UNITED STATES PATENT AND TRADEMARK OFFICE

APPLICATION NO.	FILING DATE	FIRST NAMED INVENTOR	ATTORNEY DOCKET NO.	CONFIRMATION NO.
10/078,601	02/19/2002	Xiaoming Ren	107044-0013	5541
24267	7590	01/25/2005		
CESARI AND MCKENNA, LLP 88 BLACK FALCON AVENUE BOSTON, MA 02210			EXAMINER ALEJANDRO, RAYMOND	
			ART UNIT	PAPER NUMBER
			1745	
DATE MAILED: 01/25/2005

Office Action Summary

DETAILED ACTION

FIG. 5

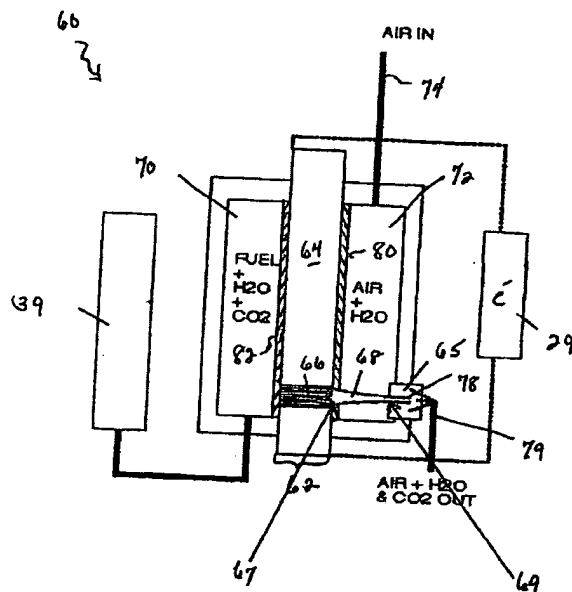
Figure 5 below depicts a passive control system using gas produced in the anode chamber for removing water from the reactive sites in the cathode chamber (SECTION 0085) wherein the CO₂ is vented out or released to the ambient environment (FIGURE 5).

As apparent from Figure 5 and Corey et al's disclosure of SECTIONS 0014, 0017 and 0020), this fuel cell system: i) can be provided with a gaseous effluent port located in the anode chamber in close proximity to the anode side of the membrane electrolyte; and ii) does not have any liquid exit port in the anode chamber per se. Thus, it has a liquid closed volume anode

chamber, and no anode liquid recirculation. These features act as a gaseous anodic product removal component. This structure also encompasses the absence of any water external pumping and/or active water removal element.

As previously mentioned, the fuel cell system of **Figure 5** above represents a passive fuel cell system (SECTION 0085). *Thus, it operates without external pumping of cathodically-generated water and without active water removal elements.*

FIG. 5

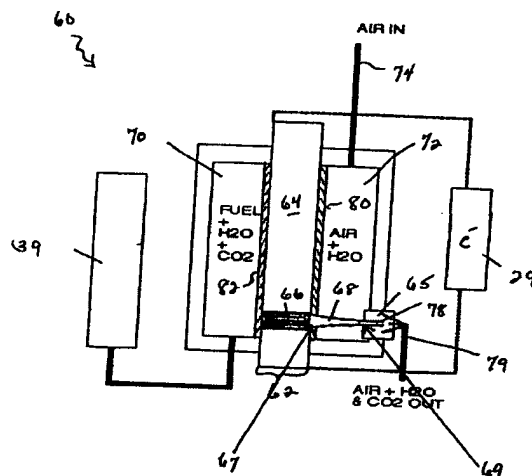
source and said anode aspect of the direct oxidation fuel cell for controlling the delivery of fuel to the anode aspect of the membrane electrolyte". In view of that and given that the prior art of record clearly teaches: that the effluents could be removed by venting the carbon dioxide out of the anode chamber (Corey et al SECTION 0014); as well as an effluent gas produced in an anode chamber of a fuel cell is collector and then exhausted through a cathode chamber of the fuel cell (Corey et al SECTION 0020); having the carbon dioxide produced from the oxidation of fuels not directly exhausted from the fuel cell system but, instead, used to remove/recirculate effluent water in the cathode (Corey et al SECTION 0017); and the fuel cell including a proton conducting membrane electrolyte separating the chambers and having an effluent gas-permeable portion allowing effluent gas produced in said anode chamber to flow into the cathode chamber (Corey et al SECTION 0026); in addition, Figure 5 clearly illustrates the CO₂ being vented out or released to the ambient environment:

thus, Corey et al clearly envisage having the gaseous effluent generated in the anode portion of the fuel cell vented out of the anode portion and into the surrounding ambient atmosphere; and having a delivery element for feeding fuel into the anode aspect of the membrane electrolyte. As

apparent from Figure 5 and Corey et al's disclosure of SECTIONS 0014, 0017 and 0020), this fuel cell system: i) can be provided with a gaseous effluent port located in the anode chamber in close proximity to the anode side of the membrane electrolyte; and ii) does not have any liquid exit port in the anode chamber per se. Thus, it has a liquid closed volume anode chamber, and no anode liquid recirculation. These features act as a gaseous anodic product removal component. This structure also encompasses the absence of any water external pumping and/or active water removal element. Hence, it is emphatically asserted that the prior art of record still provides both the necessary functional and structural interrelationship to satisfy the claimed requirement.
